7/11/02
MCPB
Item # 20

MEMORANDUM

REVIEW TYPE: Site Plan Review
APPLYING FOR: Reduction of onsite MPDUs
PROJECT NAME: Residences of Rosedale Park
CASE #: 8-02002A

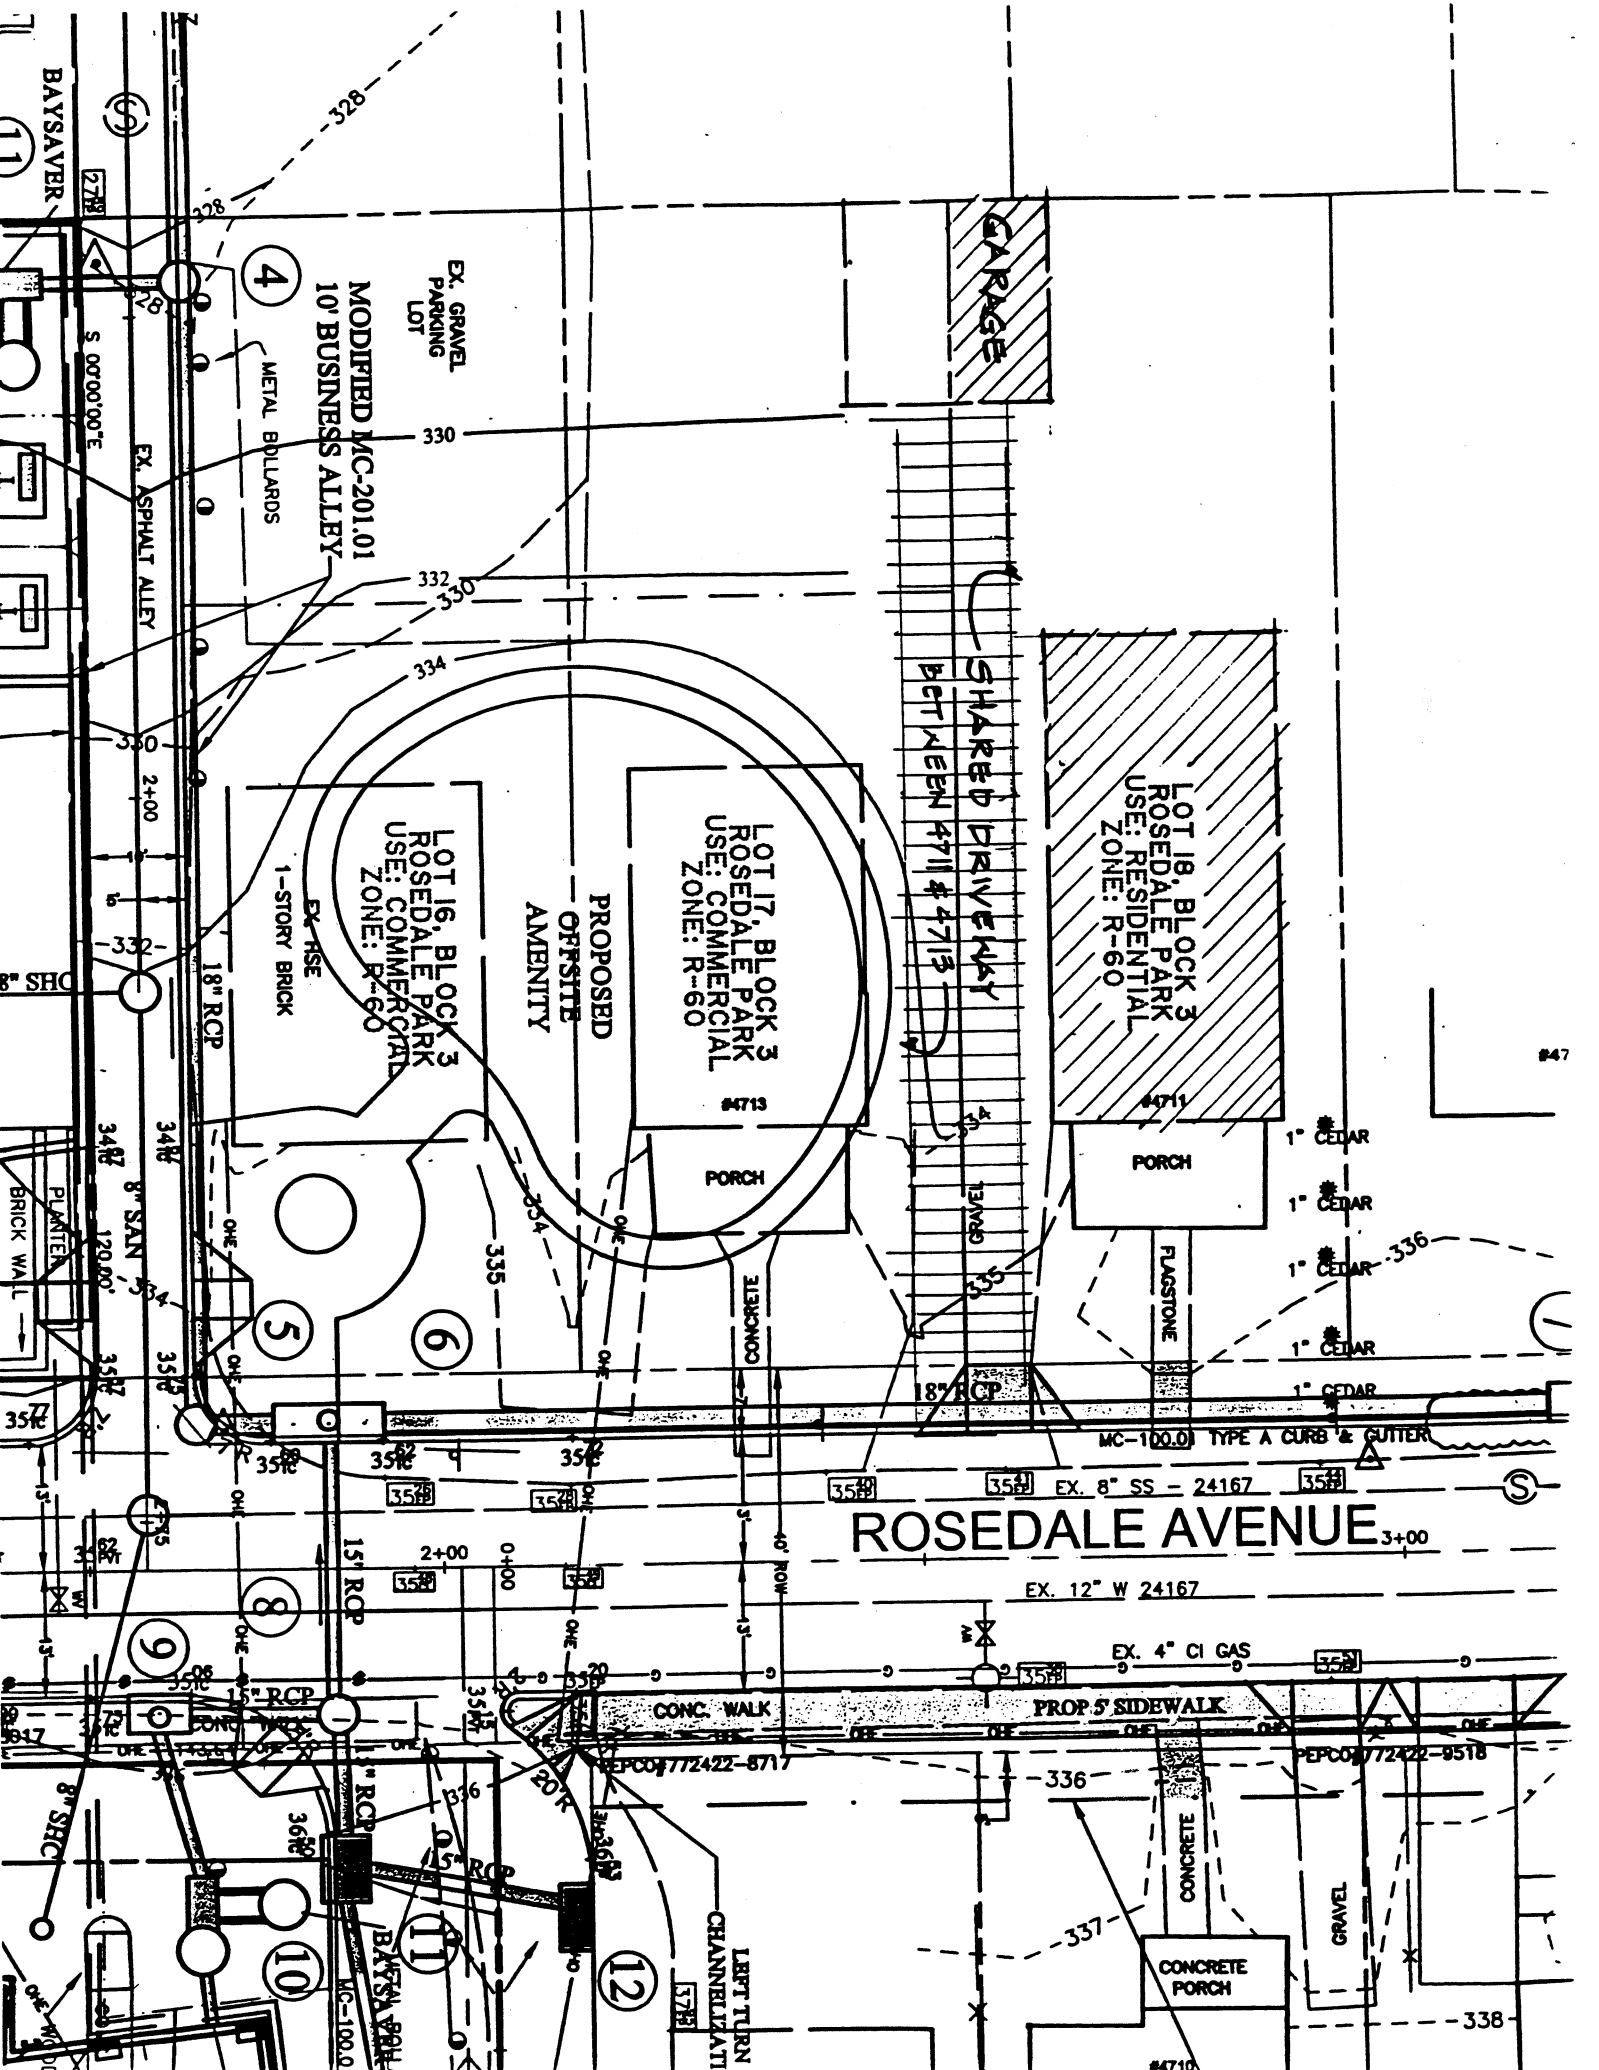
For the past 40-50 years there has been a shared driveway between my house - 4711 and 4713. (Please see the attached drawing). This is the only access to our parking at the rear. The proposed site plan presented by the Magruder team shows the east wall of the proposed park cutting right in the middle of our current driveway. This is totally unacceptable, and will make it impossible for us to use the rear parking and be able to turn around.

I have brought up this issue in the Park & Planning meeting last August, and also to the developer in few occasions, but nothing showing in the site plan has any consideration for this serious problem. Please make sure that in the site plan there is adequate space provided for a driveway and turnaround space.
